5617 CALIFORNIA AVE SW

#3041292-LU

DESIGN RECOMMENDATION PACKET (ADR) AUGUST 29, 2024

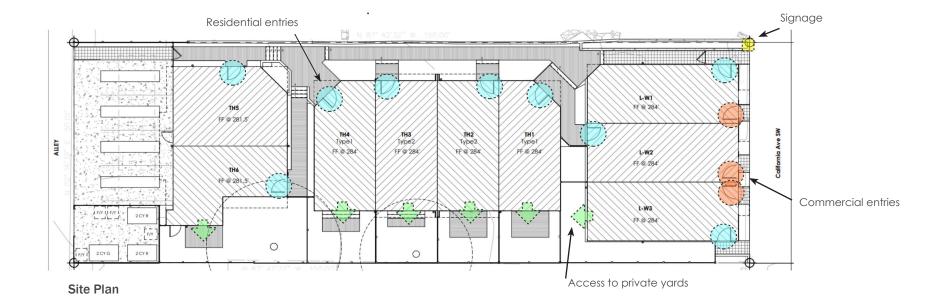
Staff questions the location of several of the proposal unit entries and suggests the following alternate locations to aid in wayfinding, access to green space, and better support the project's site planning and design concept.

- Place the commercial entires into the three live-work spaces along California Avenue SW
- Place the residential entries into the three live-work spaces are the rear of the building. A pedestrian pathway would be added between Unit 4 and the three live-works to achieve this.
- Please Unit 4 and Unit 7's entries along the chamfered edge of the building, as show for Unit 1 and Unit 8.
- Provide access to the green space at the southern portion of the site at the rear of Units 4 through 7.

Our entry has been adjusted to enhance the user and pedestrian experience on the site. All commercial entries to the live-work spaces front California Ave SW. While we didn't shift all of the live work residential entries to the back, they all avoid the street facing facade. Having two live work residential entries on the sides of the units allows for greater unit flexibility while creating private feeling entries.

Additionally, we implemented a pathway to the rear of the live work units for a more cohesive user circulation concept. The middle block of townhomes incorporates user entities along chamfered edges where possible and helps establish an open feeling in gaps between the structures. Lastly, all townhomes in the central structure are shown as having rear patio access to the green space at the southern portion of the site.

Lastly, the signage is prominent along the walkway fronting California Ave SW

Pedestrian view from California Ave SW

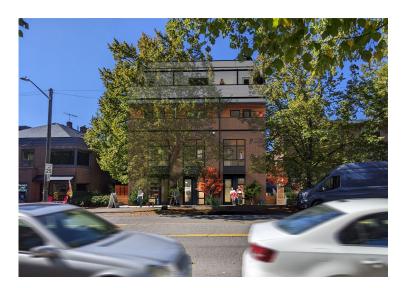
guidance	response	design guidlines
Staff indicated support for the requested departure in order to create a strong street edge, with street level live-work commercial uses, along California Avenue SW and allow the project to be broken up into three smaller buildings that better relate to the scale of the existing context in the neighborhood. The 2'-6" setback is proposed at the first two stories and levels 3 and 4 will be further pushed back from street edge, creating the appearance of a building in scale with the existing context. Reorganizing the residential entries, per the guidance above, and placing only commercial entries along California Avenue SW will help better support this departure request to create a design that better meets the intent of the Seattle Design Guidelines	The proposed design articulates all live-work residential entries along side or rear facades to support this design concept. Decks and greater setbacks for upper floors help to accomplish this massing goal and provide buffer for R.O.W. powerline infrastructure.	CS2-D-1, CS3-A-1, PL3-C

Staff indicated support for the requested departure in order to create a strong street edge, with street level live-work commercial uses, along California Avenue SW, in keeping with the neighborhood context and the expected future development in the neighborhood.	Thank you.	PL3-C

Pedestrian view between building 1 and 2

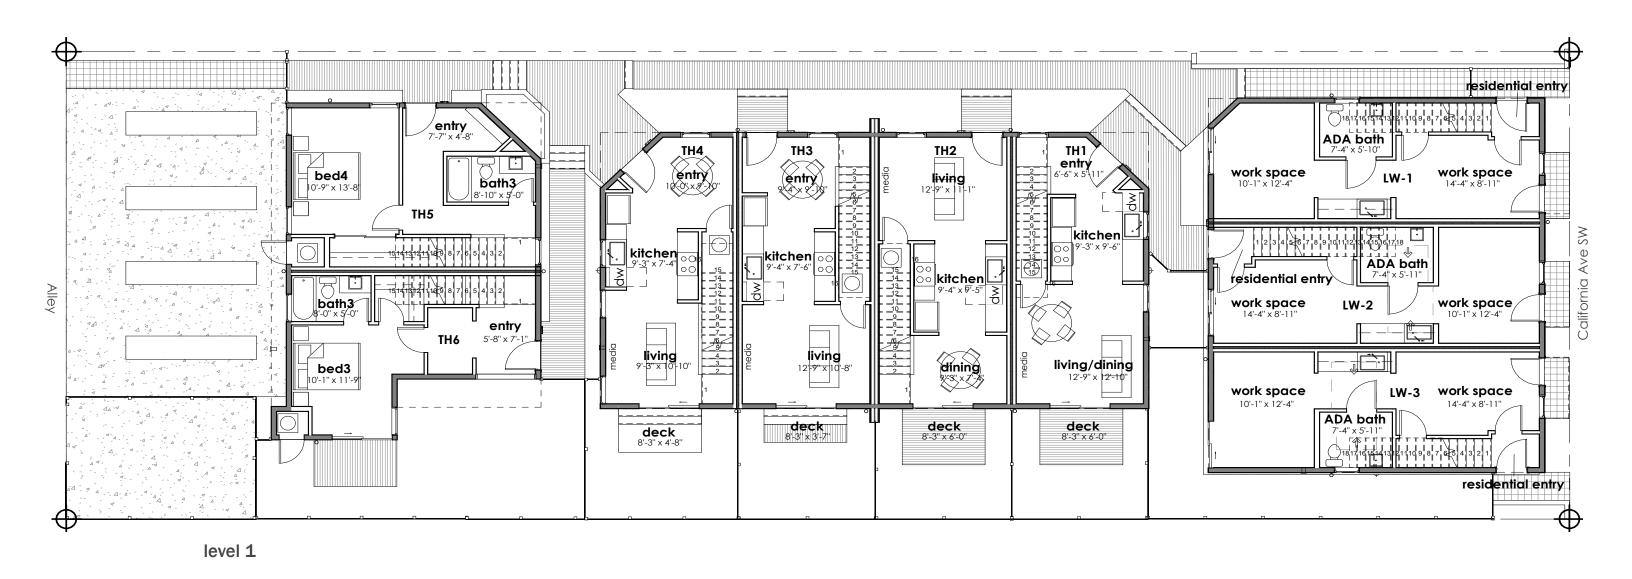
In LR and MR zones, the Code requires the minimum separation between principal structures at any two points on different interior faces to be 10 feet, except for cottage housing developments, and principal structures separated by a driveway or parking aisle. The applicant proposes a 6' separation in two locations between the three buildings. Staff indicated preliminary support for the requested departure in order to break up the project into three smaller buildings that better relate to the scale of the existing context in the neighborhood. Staff would like to see more details in the Master Use Permit plans and at Recommendation review indicating how the reduced space will be treated to make it feel less tunnel-like. Staff would also like the applicant to study carrying the chamfer to all four levels of the buildings and provide color perspective graphics and floor plans at the Master Use Permit.

As can be seen in the previous chamfer study as well as the final render images, the design pays careful attention to these building separation spaces. Through an iterative design approach, multiple steps were taken to reduce the perceived tunnel-like spaces in between structures. First, setting the central structure 8.6'from the property line opens up the spaces and breaks down the collective northern façade of the 3 structures. Next two-story chamfers are utilized on both sides of the separations to create a human-scale outdoor room to occupy. Lastly, an articulation of the boardwalk path at these separations creates opportunities for planters, landscape elements, and the incorporation of stoop conditions with the addition of steps.
